**From:** Chris LaRue  
**Sent:** Tuesday, October 1, 2019 10:51 AM  
**To:** Murphy, Chad; Peterson, Mitch  
**Cc:** Chad Schroeder; Wendi Palmer; David Pasic; Fred Starr; Deborah Bachelder  
**Subject:** Rex Ranch Filing No. 3 Preliminary Plat comments  
**Attachments:** Referral Comments.pdf

**Subject:** Rex Ranch Filing 3 Preliminary Plat - Tetra Tech Planning Referral Comments

# REX RANCH FILING NO. 3 PRELIMINARY PLAT

## COVER SHEET

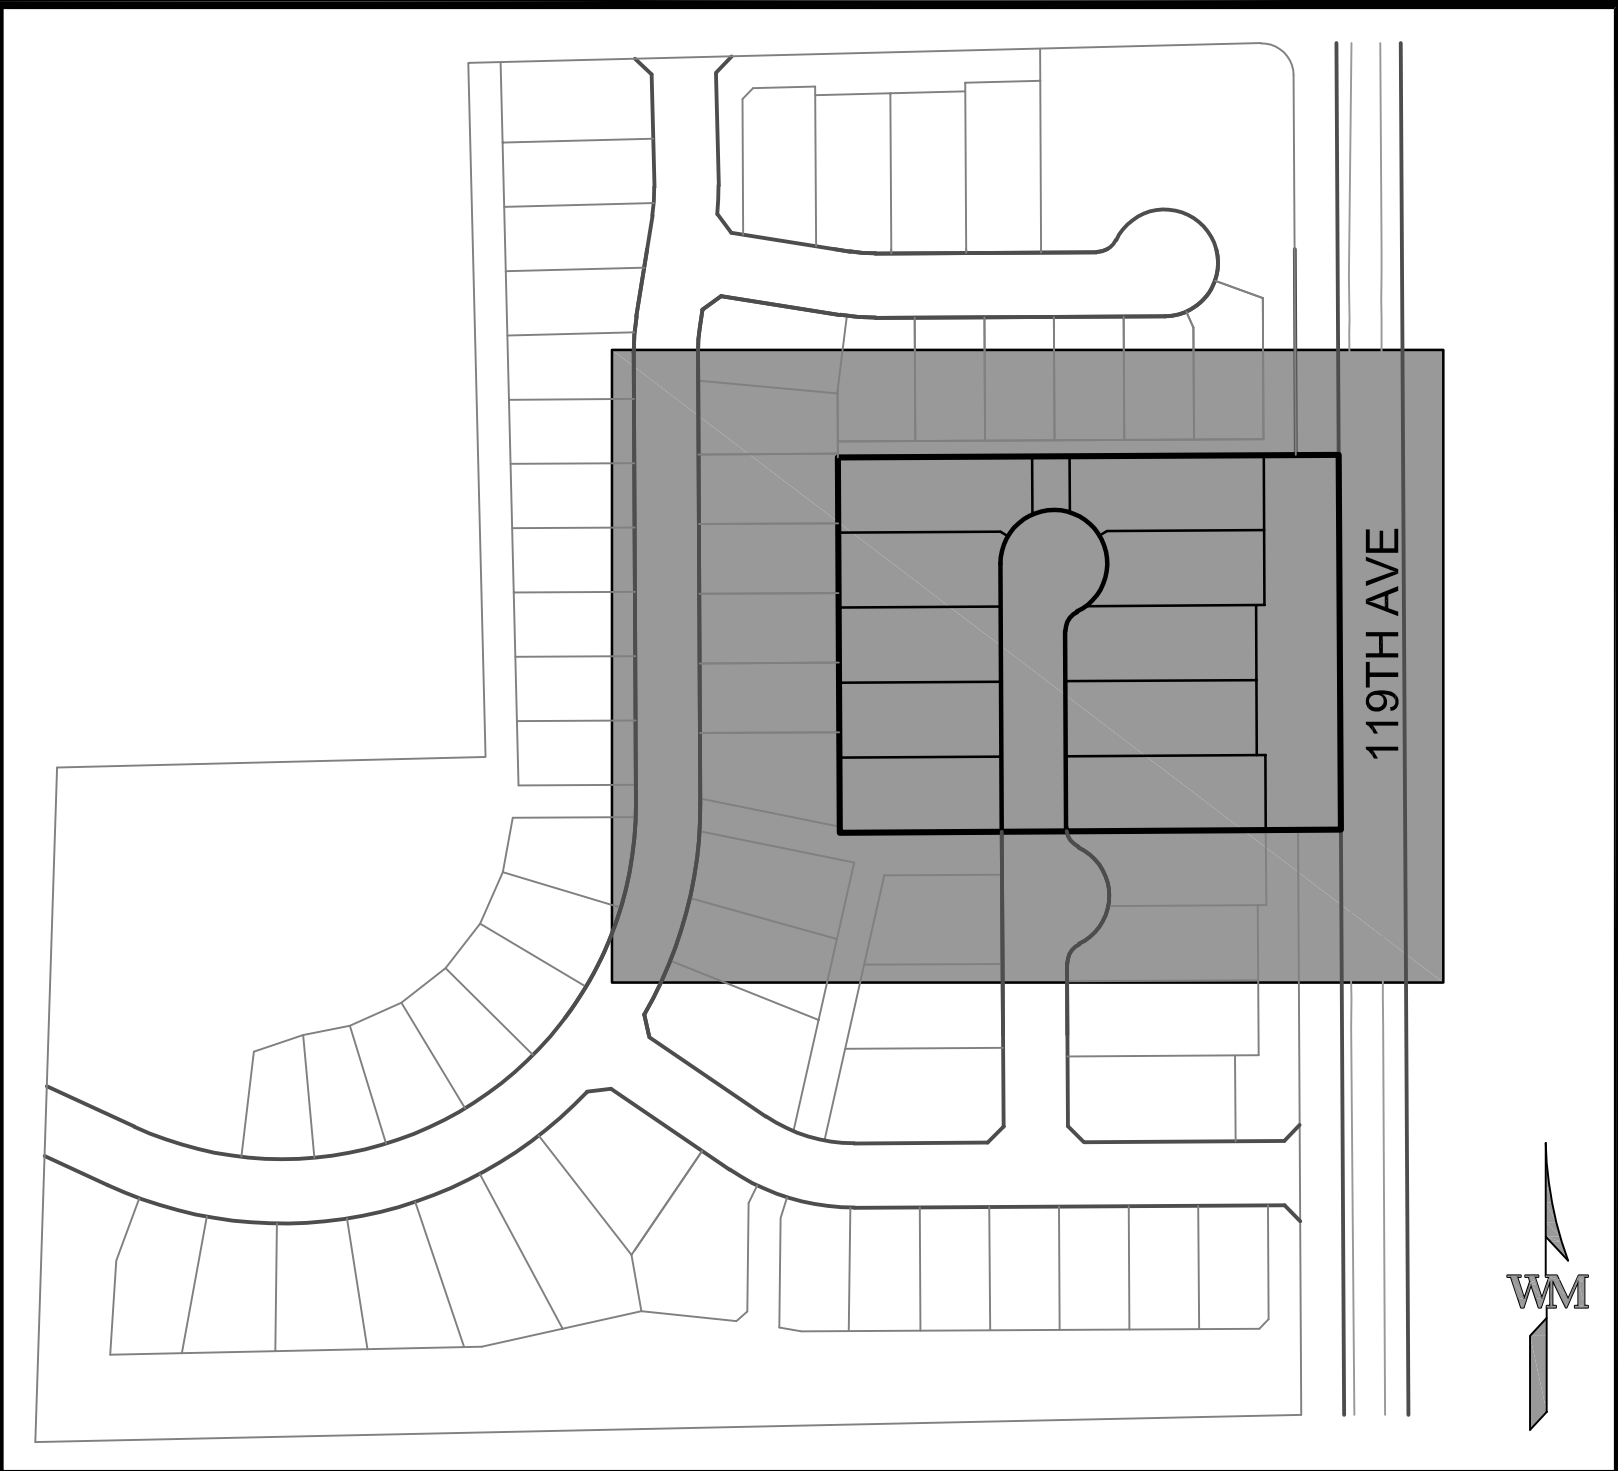
- c. Remove the housing diversity note from the Preliminary Plat. This will be addressed with the AEC request.
2. You recently discussed changing the lot widths for Lots 6 & 7, however, this would mean decreasing the width of the trail easement. The previous sketch plan comments stated:

[Tt comment: The acreage within each lot is not listed to the nearest .01 of an acre – this should be modified on the plat.](#)

Tt comment: the key map on page 2 should label the other Rex Ranch filings.

## AREA GRADING PLAN

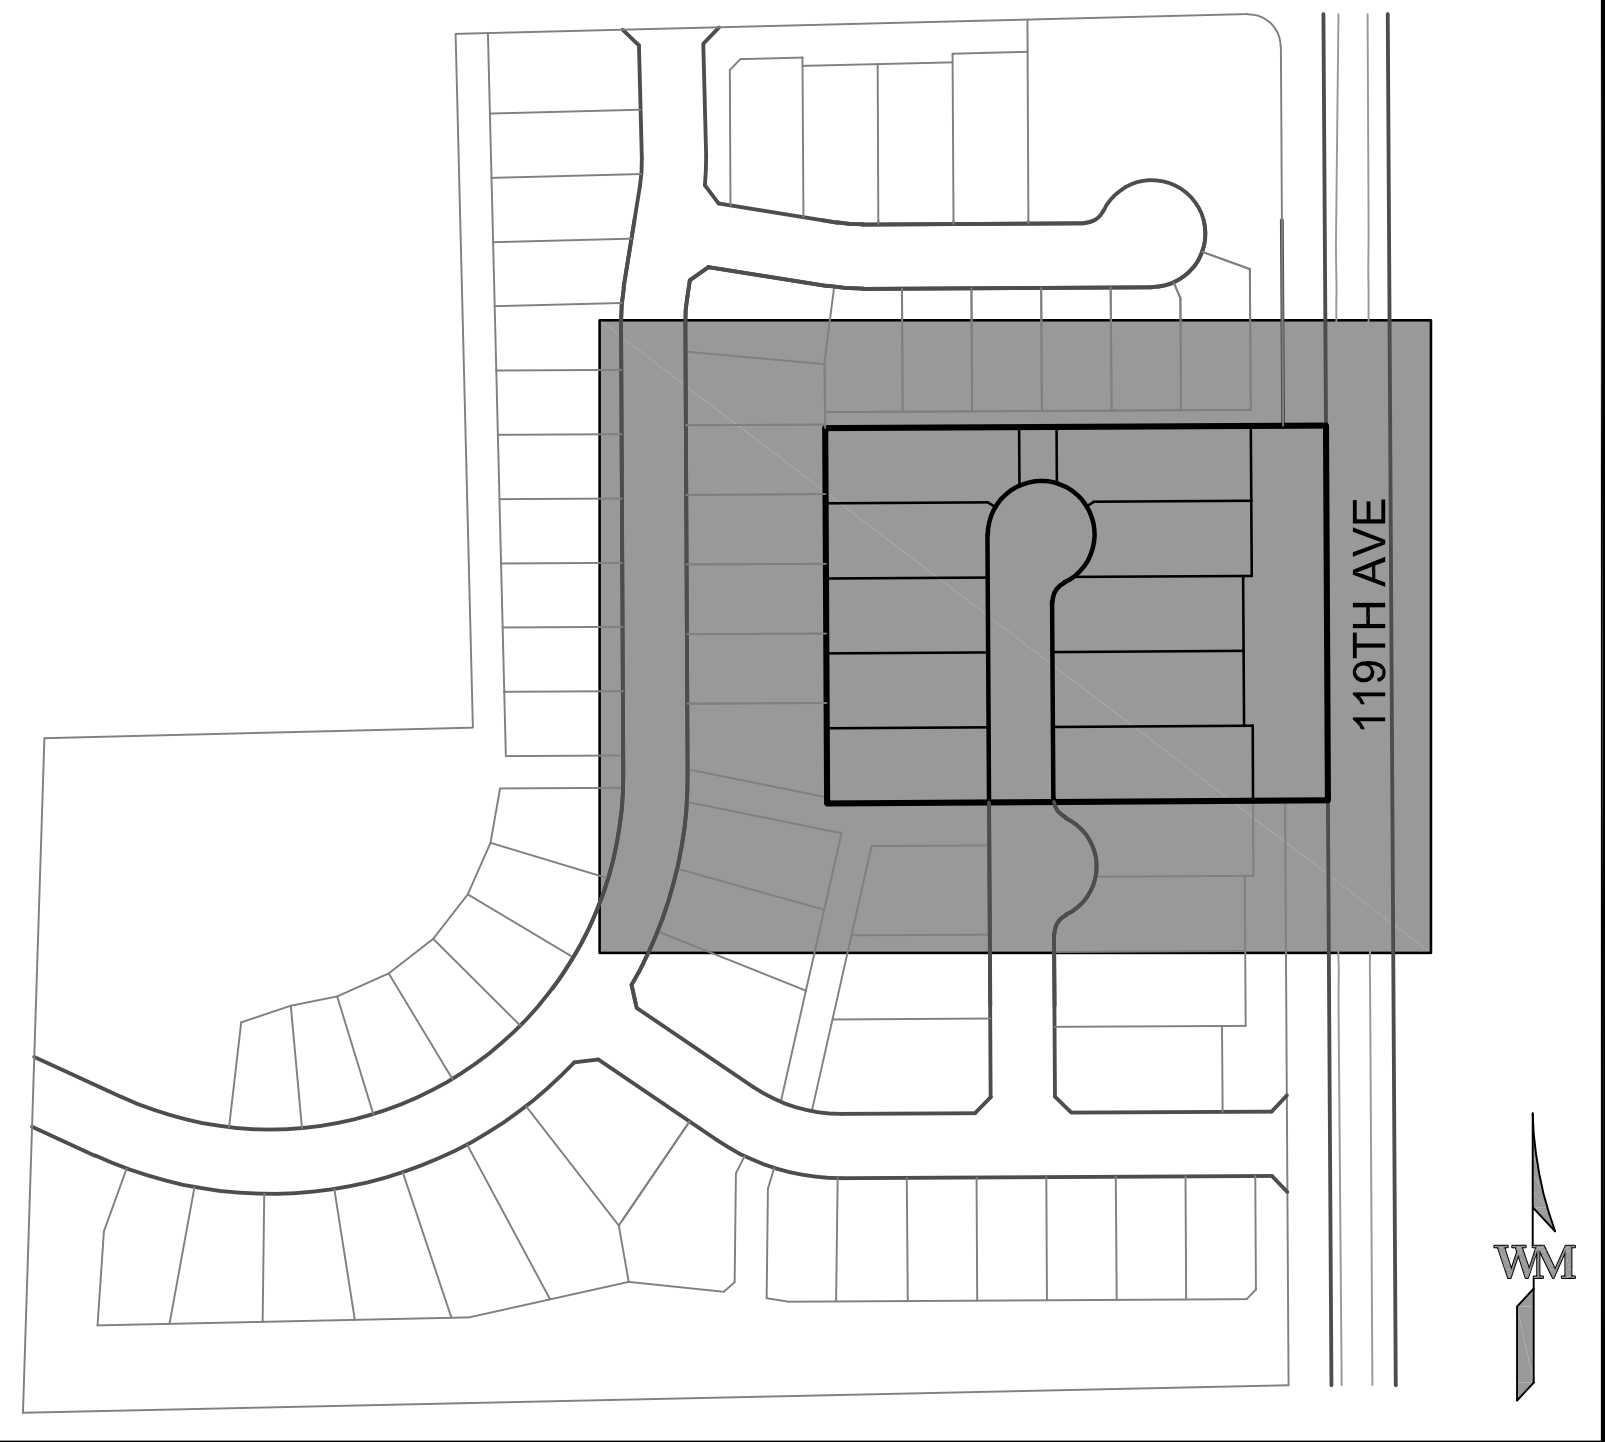
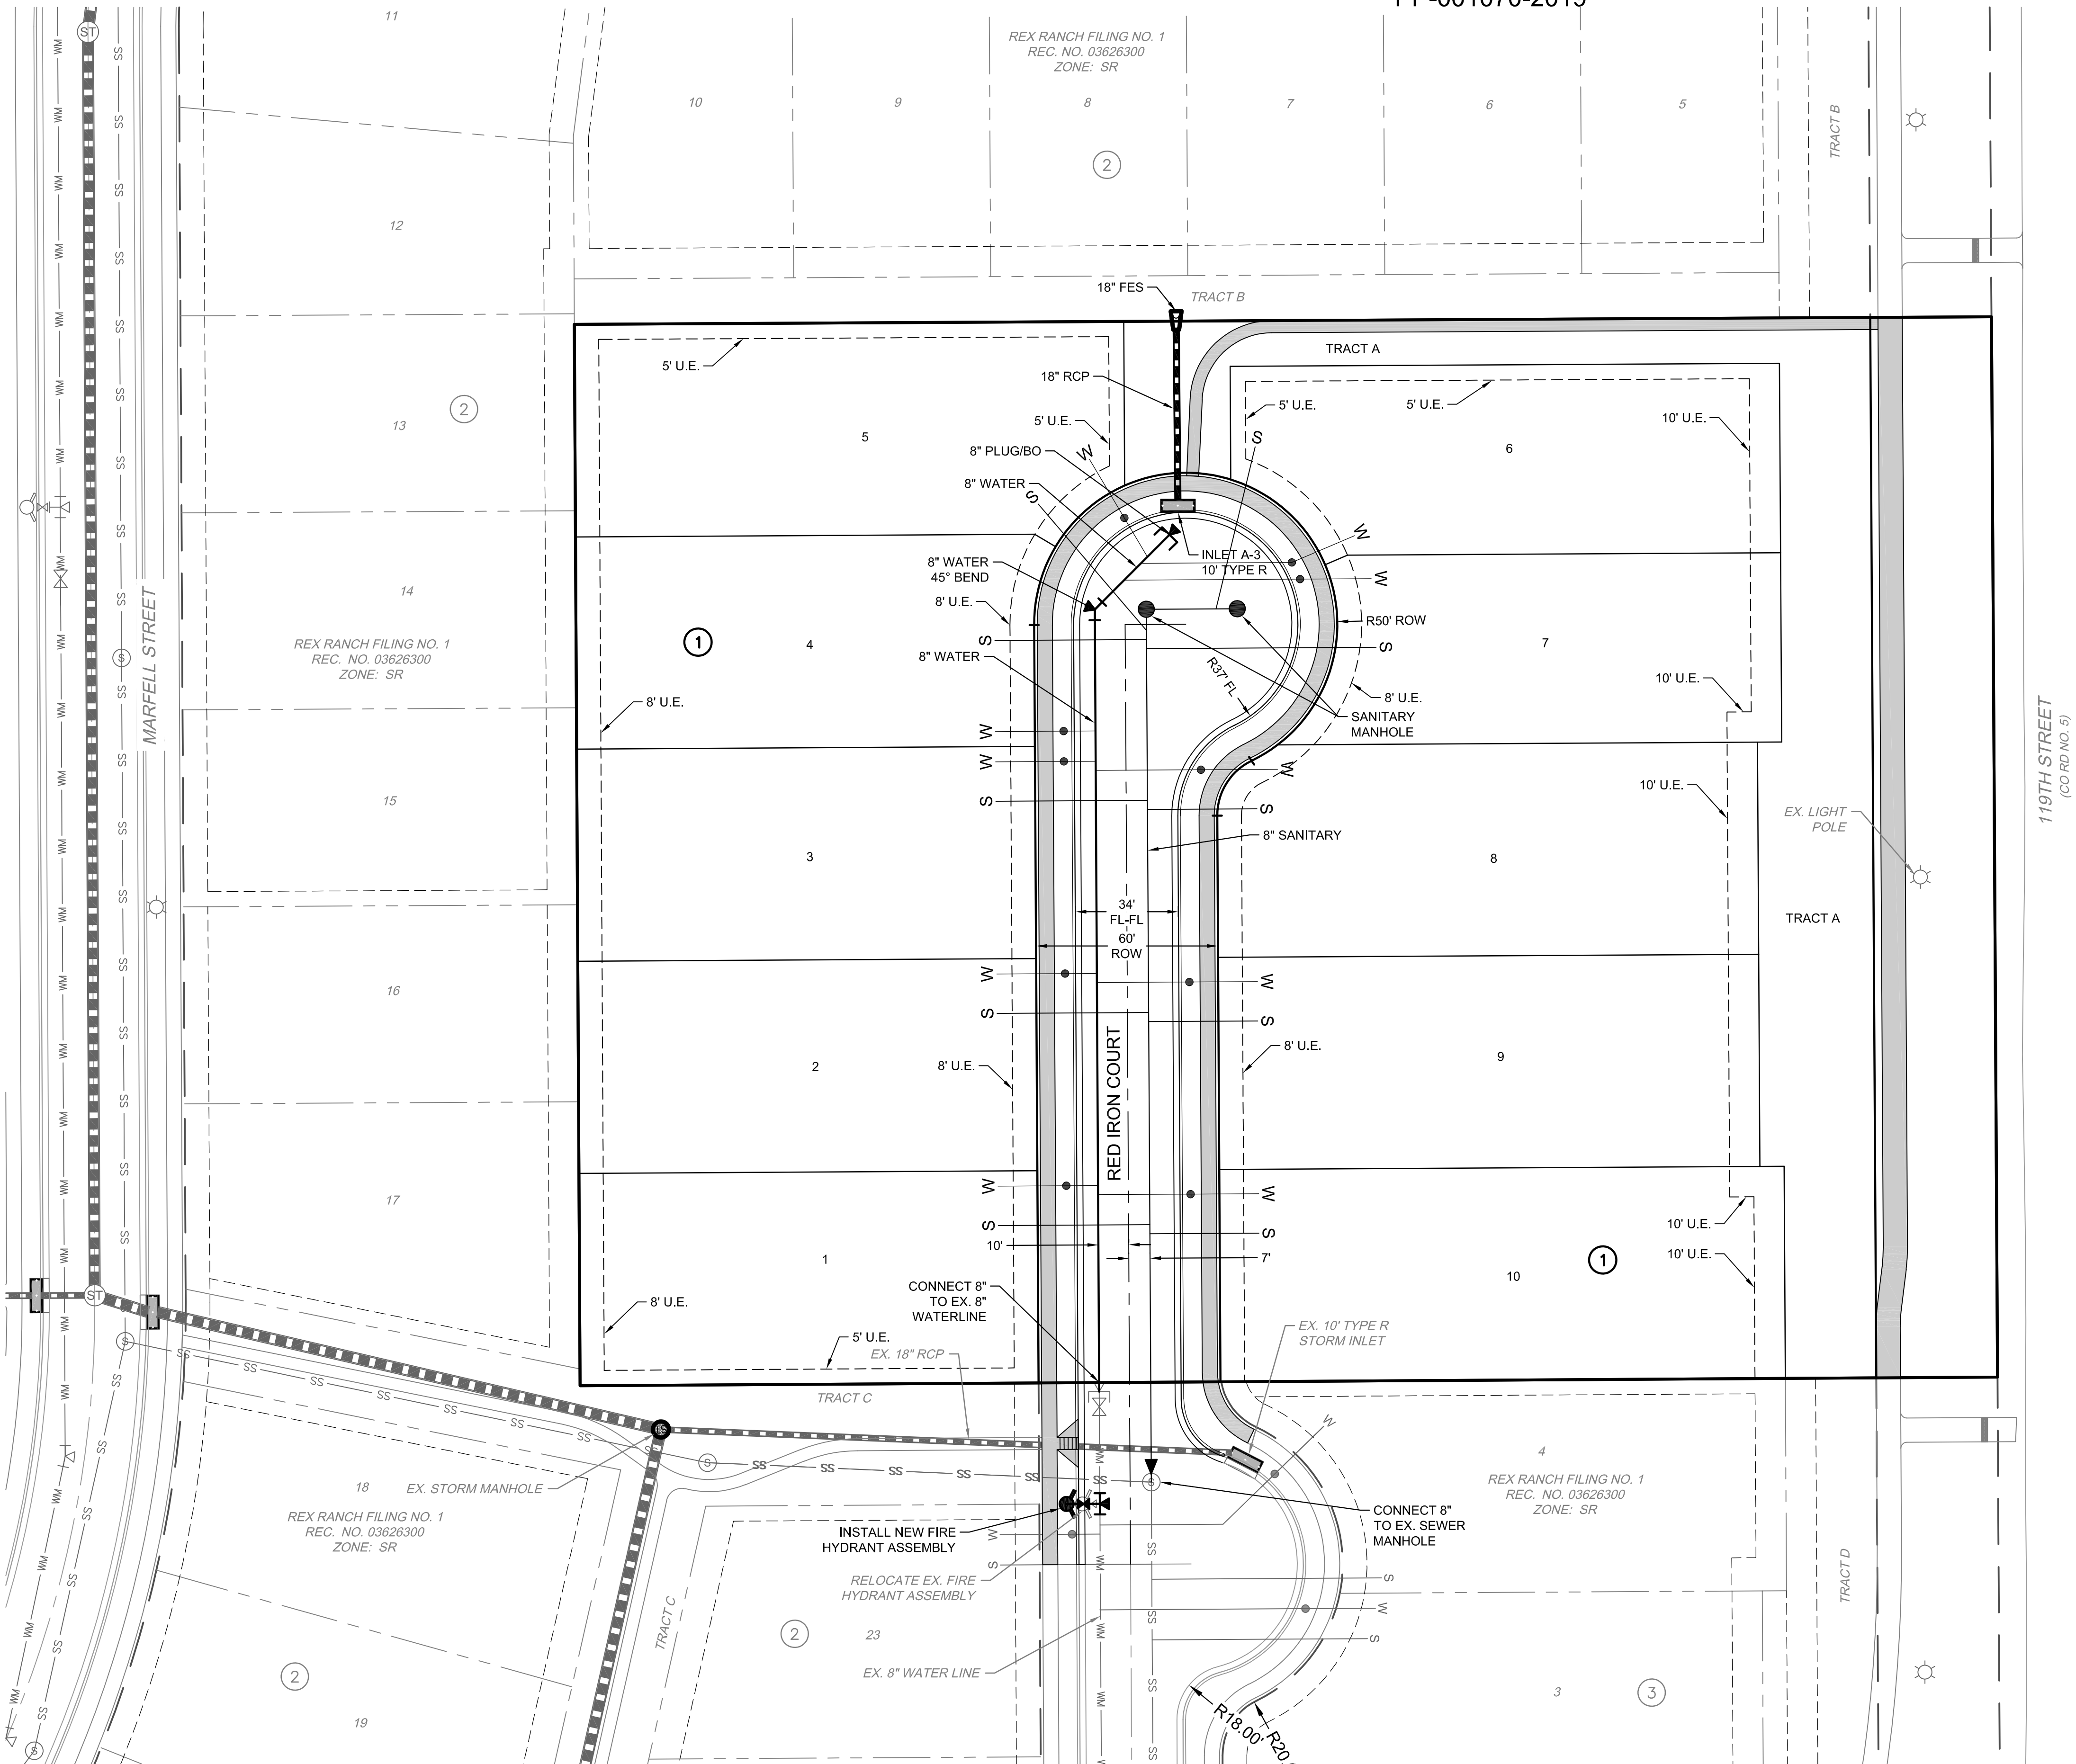
1. The direction of the bearings on the plat boundary should match the legal description. This can be corrected with the Final Plat Submittal.
2. On both the erosion control and area grading plan, revise the grading at the northeast corner to demonstrate how drainage from lots 6 and 7 reach the swale in tract B of Filing 1 and reach the existing detention pond.
3. The stormsewer in tract B should be directed so the storm flows enter the drainage swale without eroding. It is currently pointed perpendicular to the swale.
4. Show street lights needed for Red Iron Court. Assume one will be required at the end of the cul-de-sac.
